Technical Service Bulletin: TSB210113	Released Date: 30-Jul-2021
Fuel Rail Assembly Inspection and Repair Procedure: External Fuel Leaks

Fuel Rail Assembly Inspection and Repair Procedure: External Fuel Leaks

Figure 2, Removing Sealing Washer from Fuel Rail.

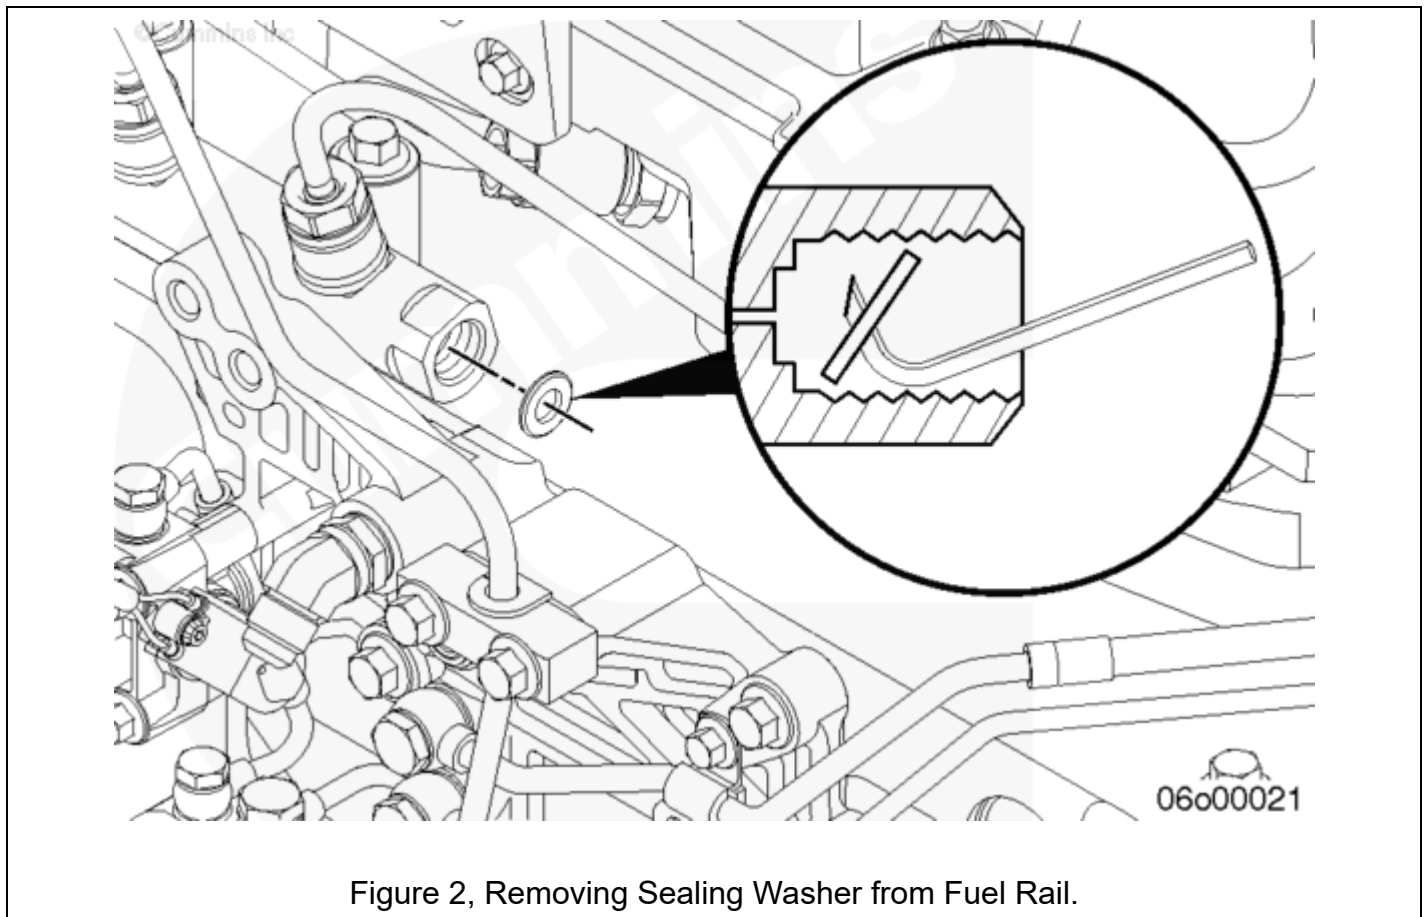
- Remove and discard the sealing washers. The procedure below outlines how to remove the sealing washers.

- A special tool **must** be created for the removal of the sealing washers by grinding a 45 degree angle on the short leg of a 1/8-inch or 3/16-inch Allen wrench, so that the wrench is no longer than 13 mm [½ in] long (measured from the outside of the long leg.)
- This tool acts as a mini heel bar to pry out the sealing washer without damaging the back of the hole.
- Use the modified Allen wrench to pry out the old sealing washer from the threaded hole in the fuel rail. Considerable force is required to remove the sealing washer.

Figure 3, Threads That Do Not Meet Reuse Guidelines.

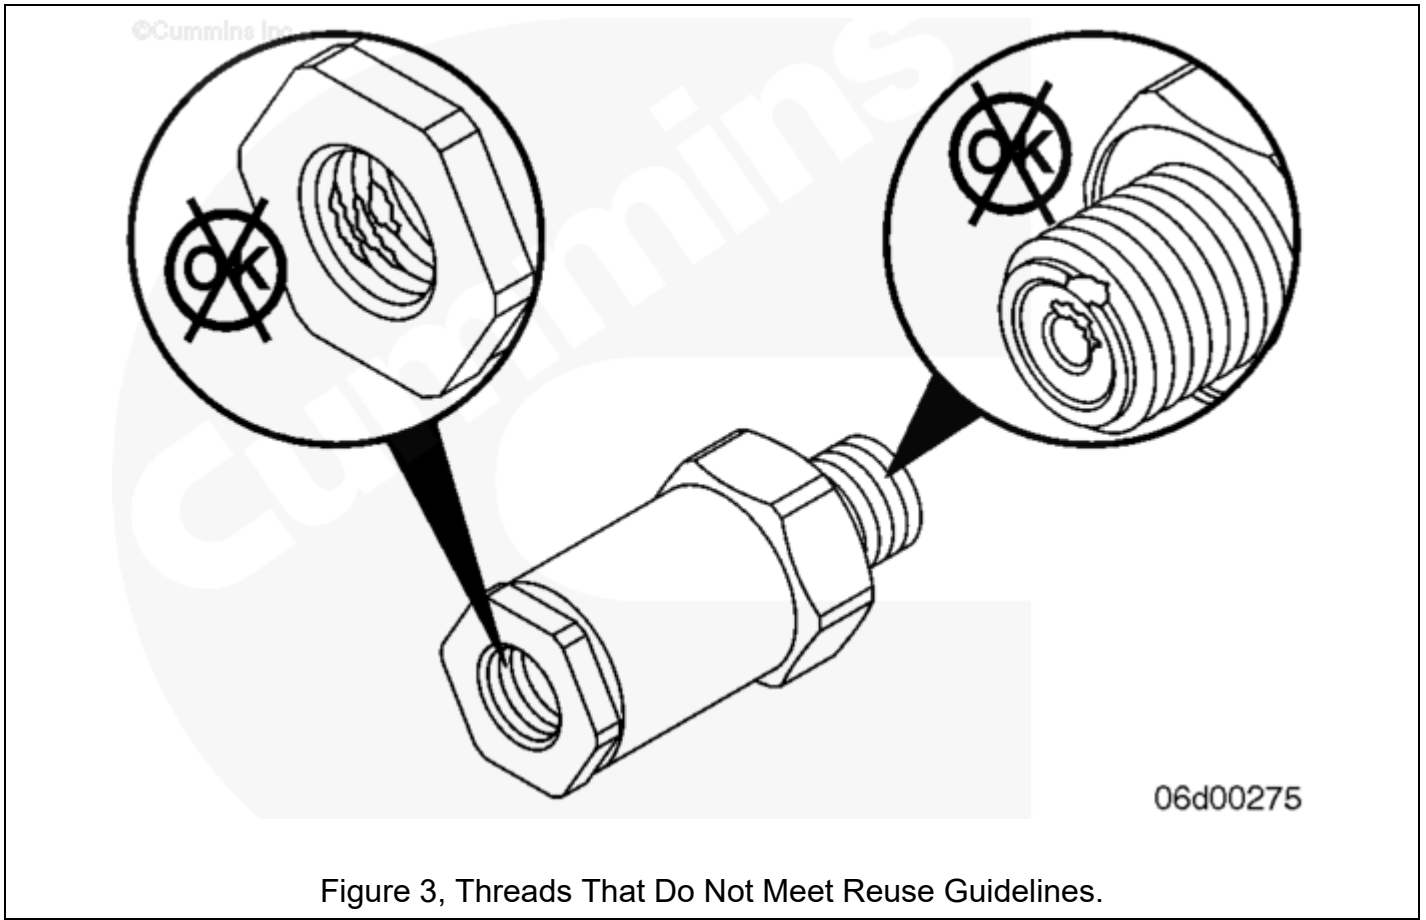
- Visually inspect the thread surfaces of the fuel rail, fuel pressure relief valve and the high-pressure fuel fitting for damage. Review Figures 3 and 4 below for guidance.
- Do **not** reuse components if the threads or sealing surfaces are damaged.

Figure 7, Installing Sealing Washer with The Seal Installer Tool.

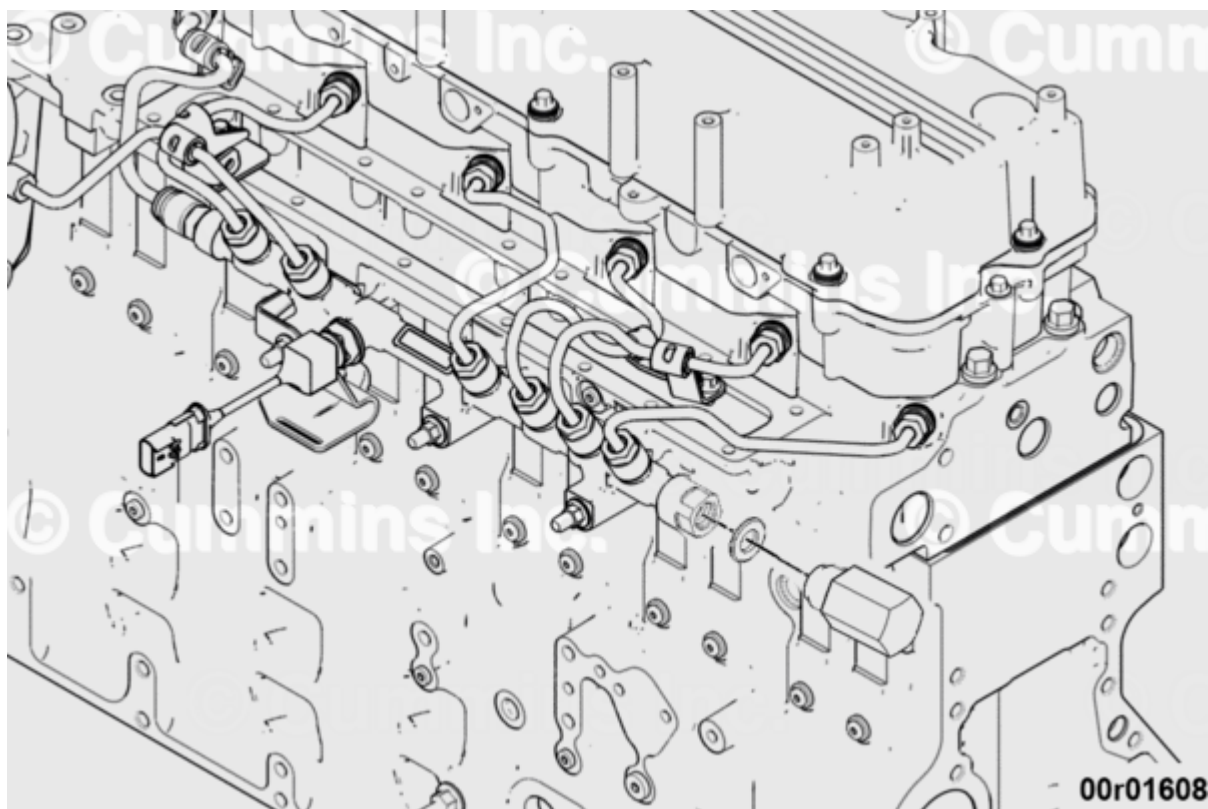
2. Install a new sealing washer on the pressure relief valve bore in the fuel rail. Use assembly lubricant, Part Number 3163087, or equivalent, on the threads and the face of the seal installer tool. Use seal installer tool, Part Number 5573487, to seat the sealing washer fully in the fuel rail bore.

3. Torque the seal installer tool.

Torque Value: 81 n•m [60 ft-lb]

Figure 8, Left: Sealing Washer Not Installed, Right: Sealing Washer Installed Correctly.

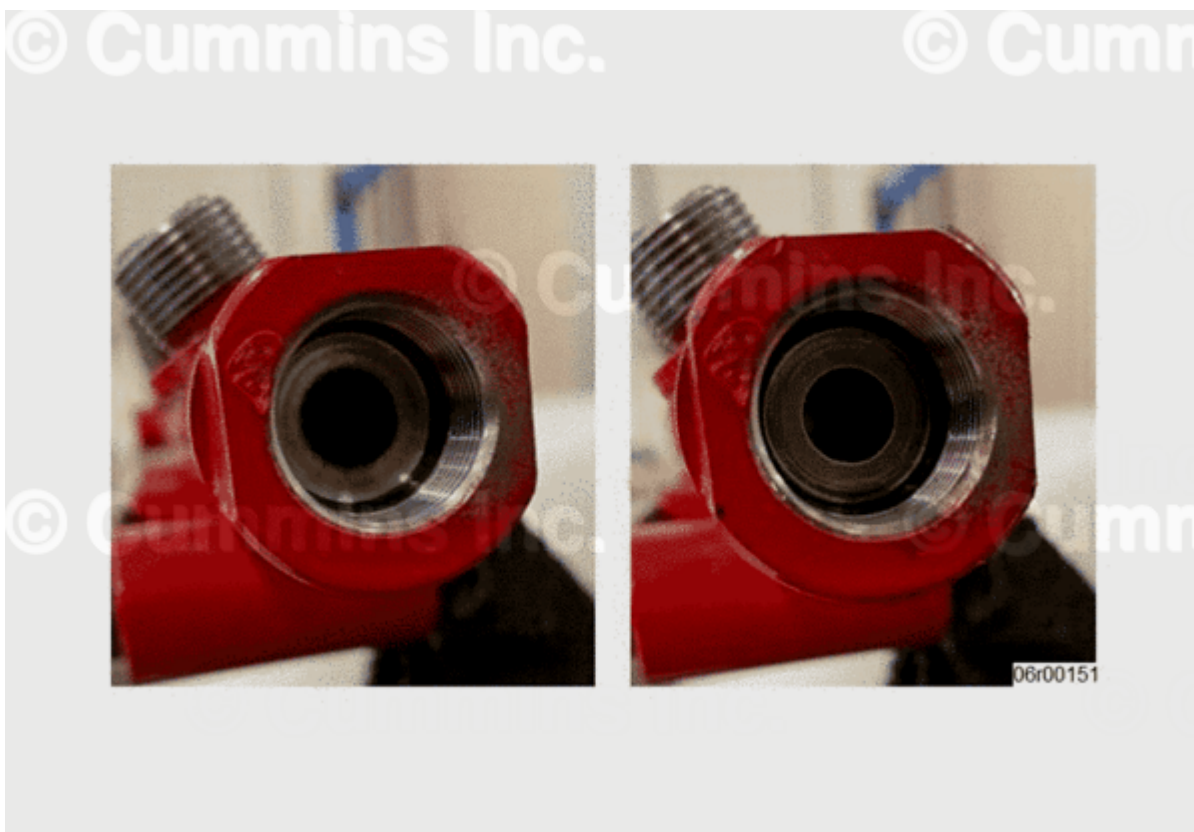
4. Remove the seal installer tool after the sealing washer has been installed. Verify that the sealing washer remains seated inside the fuel rail after the seal installer tool is removed.
